MSC-05101

APOLLO 14 MISSION  
ANOMALY REPORT NO. 1

FAILURE TO ACHIEVE DOCKING PROBE  
CAPTURE LATCH ENGAGEMENT

MANNED SPACECRAFT CENTER  
HOUSTON, TEXAS  
OCTOBER 1971

Figure 12.- Side load reaction on torque shaft operation.

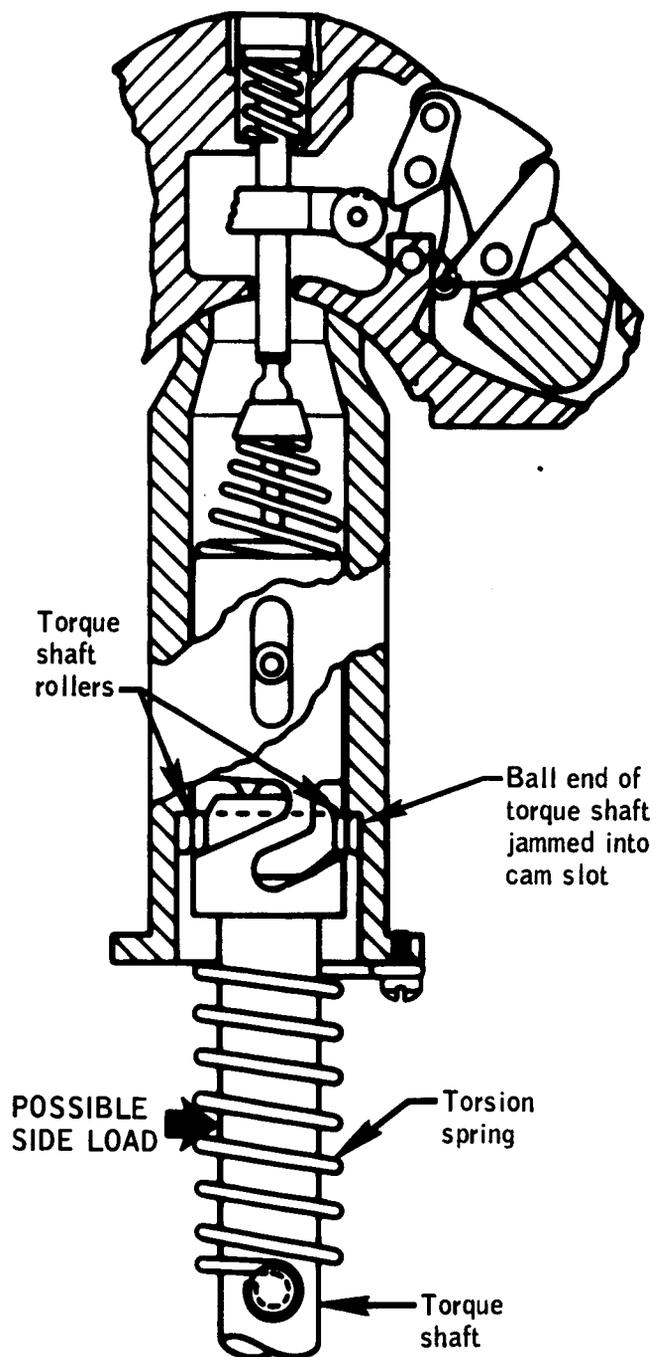
The first possibility is that of a side load being introduced into the torque shaft (fig. 12) by the torsion spring or by other means; this may cause the ball end of the torque shaft to bind against the cam. This failure occurred on another probe during acceptance tests and it was possible to demonstrate this same failure on the Apollo 14 probe by applying a side load, but the failure did not occur consistently.

The failure to achieve capture-latch engagement has been narrowed to either foreign material restricting the normal function of the capture latch mechanism or jamming of the translation cam.

1. The probe translation-cam assembly (fig. 15) was modified to eliminate possible binding of the cam and spider.
  - a. The diameter of the ball machined on the forward end of the torque shaft was reduced.
  - b. The roller pin surface was machined to allow a rocking motion between the roller pin and hole in torque shaft.
  - c. A spherical surface was provided on the roller ends and roller pin ends for improved clearance.
  - d. An alignment bushing was added to insure proper torque shaft alignment.
2. A requirement was added to test the probe in the horizontal as well as vertical position during the capture latch timing test of the acceptance testing.
3. Capture latch timing tests were added just prior to the countdown demonstration test for the latest possible verification of latch operation in the spacecraft checkout flow.

Figure 14. - Probe-tension tie changes .

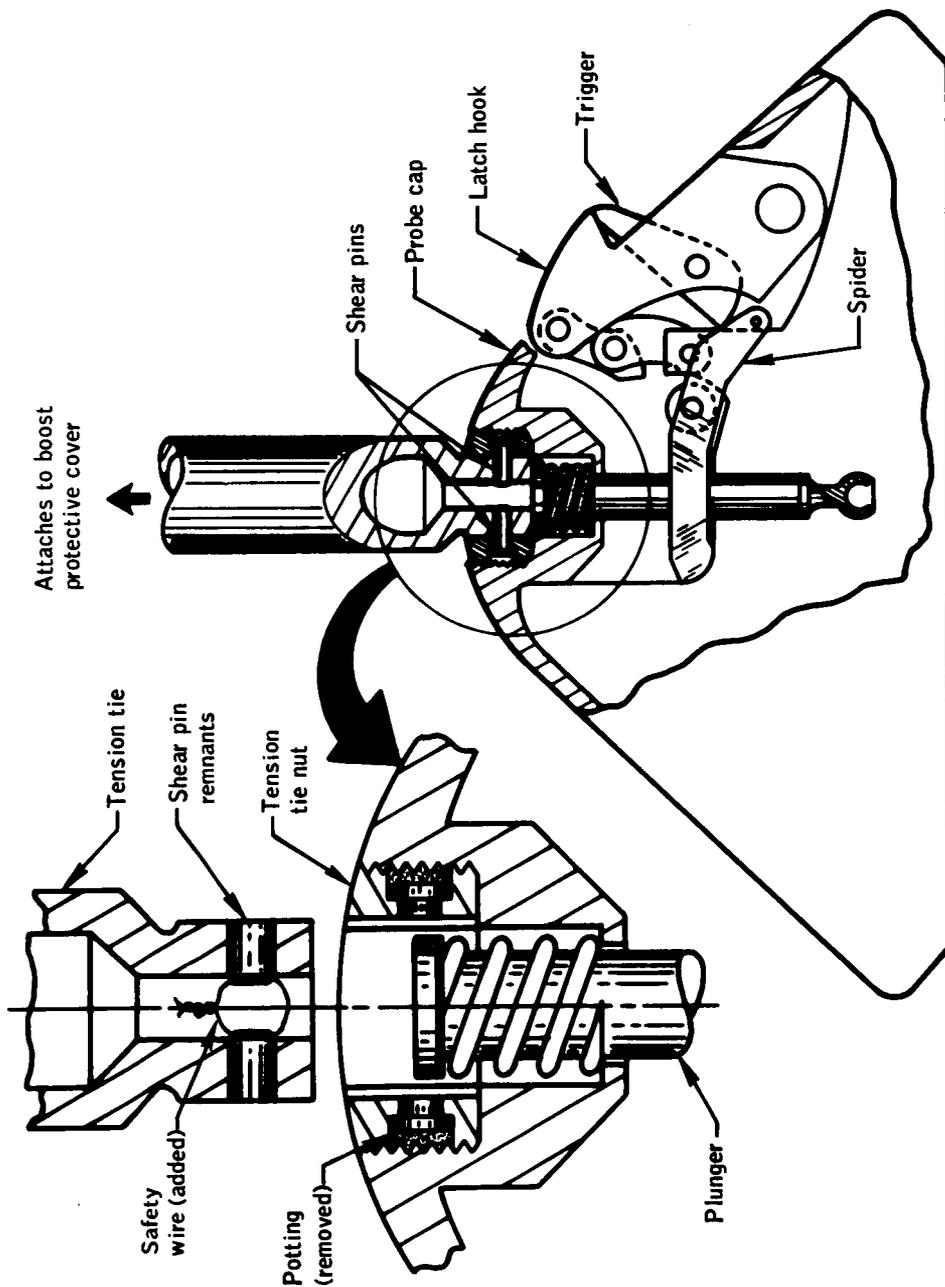
The second possibility is that some small foreign material may have been lodged in the probe in a manner that prevented operation of the mechanism. Burrs from an unknown source were discovered in the bore of the tension-tie plug (fig. 13). A foreign particle might have been lodged between the plunger and the plug and may have caused the problem.

The following changes have been made to prevent the introduction of foreign material into the probe mechanism:

1. A removable cover was provided for the probe head. The cover will be installed at the completion of acceptance testing and remain in place until the tension-tie assembly is installed at the launch complex. It will be removed only when the probe is being tested.
2. Cleanliness requirements for all ground support equipment mating with the probe have been implemented.
3. Use of cleaners or primers when potting the tension tie nut during installation has been prohibited.
4. Shear pin remnants in the tension tie have been safety wired, and the potting holding the shear pins in place has been removed (fig. 14).

Figure 15.- Cam assembly modifications.

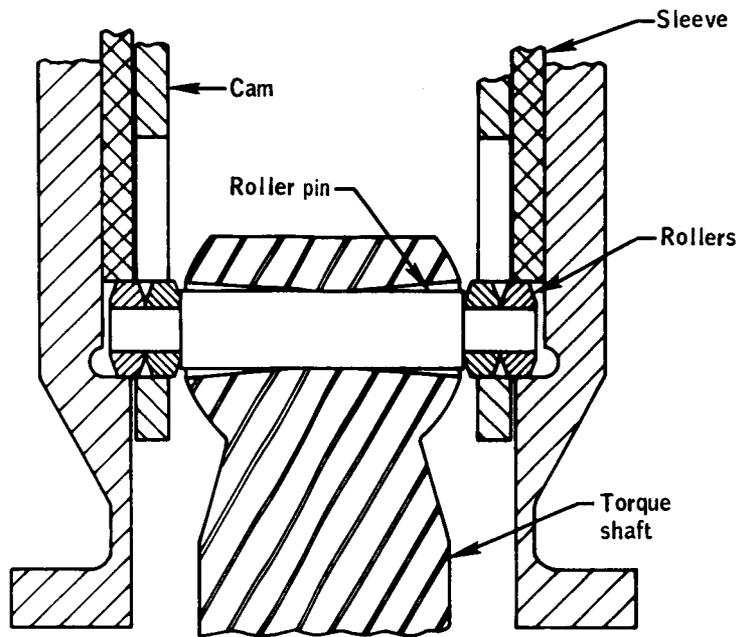
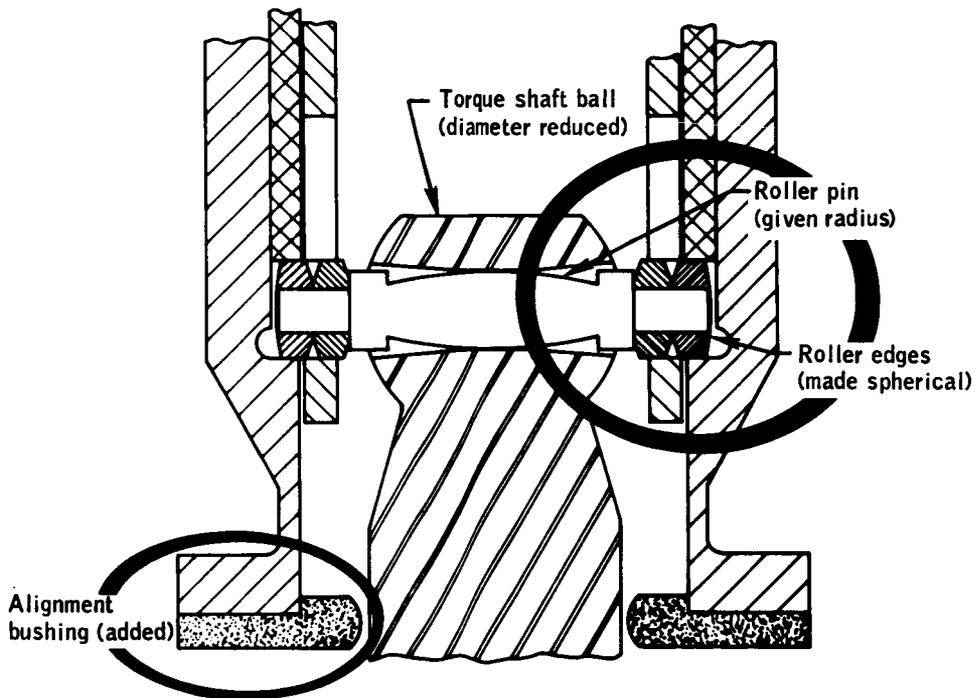
The following changes have been completed to minimize the possibility of a translation cam malfunction:
